LONDON STANSTED AIRPORT FUTURE AIRSPACE

Stage 2 – phase one Stansted discussion sessions feedback

Constraints and boundary for departures and arrivals - feedback

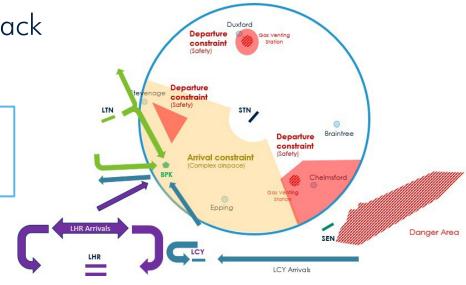
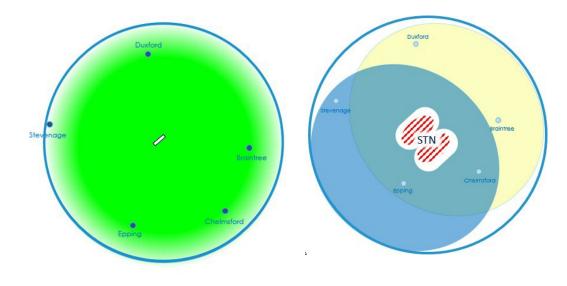
- Housing have new developments and local plans been considered
- How will alignment with other ACPs be managed
- How will STN proposal affect other airspace users
- Overall most stakeholder understood the presented constraints
- However, some questioned if the identified constraints limited our approach.

"Are you not being a bit limiting by using GVS (gas venting stations) and DA's (danger areas) as no go areas? GVS are fairly low-level restrictions (and probably below the climb profiles) and DA's are activated and deactivated by notam.

"If Stansted design is constrained by NATS upper air structure, is there benefit in influencing that as part of the Airspace Modernisation process? Similarly, noting the area constraint imposed by Luton departures, would there be benefit in harmonising Luton and Stansted procedures to maximise efficiency at both?" – Aviation representative

Departures options - feedback

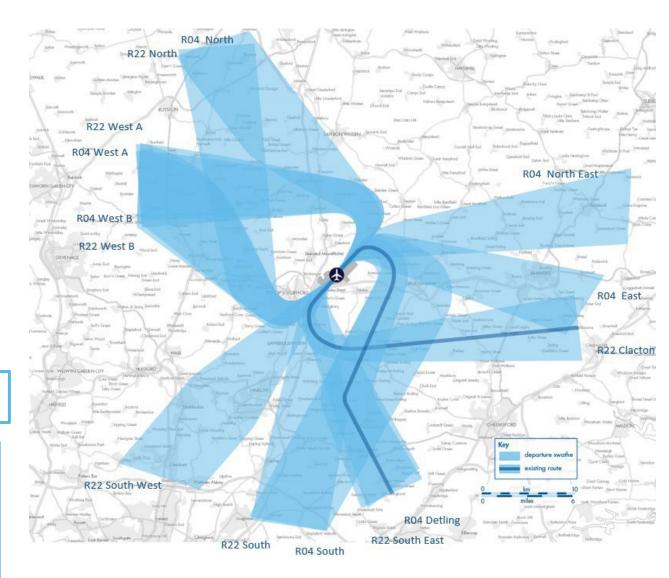
- Support for options that create respite was the most common feedback theme from council and community stakeholders and was acknowledged as desirable by airline stakeholders
- Stakeholders, particularly airlines, support the introduction of the additional envelopes
- One aviation representative supported the 04 North East envelope but raised some concerns about R22 South West
- Mixed feedback on PBN from council and community stakeholders – linked to respite
- Support for increased climb gradients albeit one questioned overall emissions impact of quicker climb
- One stakeholder requested consideration of an area outside of envelopes
- Limited feedback about the position of the existing R22 Clacton and 04 Detling routes.

"I think the southwest route, if you could make that happen, that would be a game changer." – Aviation Representative

"This southwest departure is perfect for us ..."-Aviation representative "The only comments that Councillors have at this time is that they welcomethe proposals to have alternate routes to allow for 'relief' of areas that are frequently overflown." – Elected representative
